**Dorchester Town Council**  
**Minutes of the Planning and Environment Committee**  
**3 August 2026**

**17. Planning Application P/OUT/2026/03215 Land west of A35 and east of Slyers Lane North of Dorchester**

**P/OUT/2026/03215 Land west of A35 and east of Slyers Lane North of Dorchester**

*Prepared by Jo Witherden BSc(Hons) DipTP DipUD MRTPI, August 2026 on behalf of Dorchester Town Council*

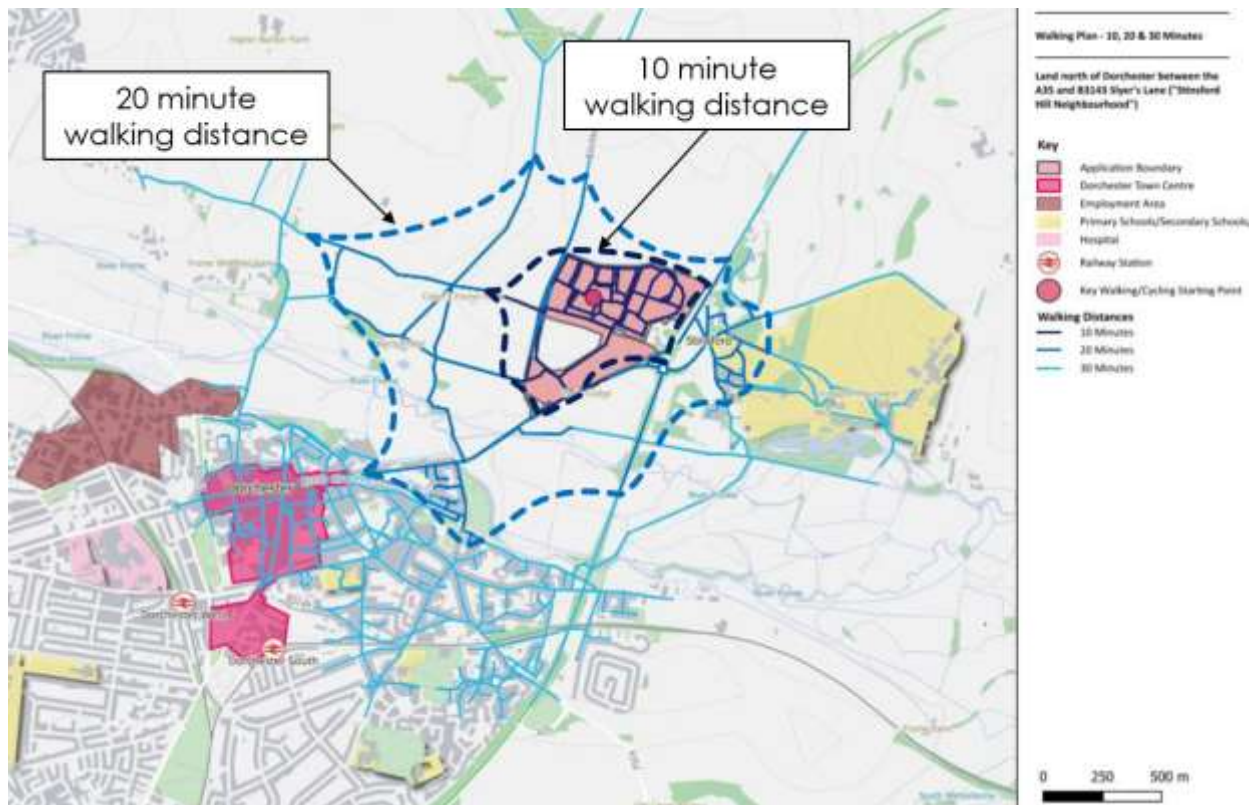
It is generally accepted that a “walkable” distance for everyday facilities is around 800m (a 10-minute walk), with shorter distances for bus stops (400m). This is reflected in paragraph 63 of the National Design Guide and published advice from Active Travel England, as well as Manual for Streets. 800m or 10 minutes' walk time (which may reduce the overall distance depending on topography, route availability and quality or physical barriers) also features in the most recent NPPF glossary definition of “reasonable walking distance”.

Yet the 10- and 20-minute walking isochrones (based on the applicant's maps) show the reality of the isolation of this proposed neighbourhood.

The 10 minute walk barely reaches beyond the site boundaries, highlighting the reliance on facilities within the development itself. Even the 20 minute walk only reaches the edge of the town, and does not extend to the town centre, the train stations, major employment areas such as the hospital site, or the local schools. Anyone willing to walk the considerable distance into town may also be deterred given a significant proportion of this walk would be along the side of the B3143 and B3150 London Road, not overlooked by properties and unlikely to feel safe for more vulnerable residents including women and children.

No consideration is given to the safe crossing of the junction of Grey's Bridge (where there is no provision for pedestrian or cyclist crossing at the signal-controlled junction), or the routes as they continue through the town. The same applies for cycle journeys, which given the distance would be the more viable option for those with adequate fitness levels, yet Dorchester lacks safe dedicated cycle routes. The Council may not be obliged to provide dedicated bus transport to the schools, but very few parents are likely to support their children walking and cycling these distances with the lack of safe, dedicated paths provided. This appears to be acknowledged in the applicant's own transport assessment, which does not anticipate any journeys to school on foot, and only 6 out of 323 journeys by cycle. How will the scheme ensure residents can freely, safely and easily access the town facilities, particularly children, residents in affordable housing on limited incomes, and those with limited mobility, and that this does not become a car-led development?
